# ARCHITECTURAL & DESIGN REVIEW APPLICATION

FITCHBURG TOWNHOMES  
FITCHBURG, WISCONSIN

Application: RZ-2201-18, CS-2202-18 & ADR  
Property Location: Outlot 1 CSM 14487  
Review Date: February 22, 2018  
*Planning Staff Review #1*

**LANDSCAPE PLAN**

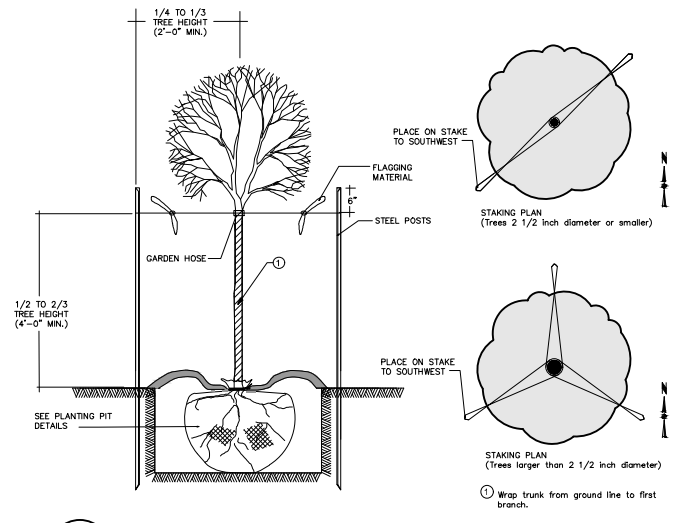
7. The front landscape plants are very uniform. Can you mix up each section with some evergreen and other types of plants. The landscaping has been adjusted. Please see "Updated Landscaping Plan" pdf attached.
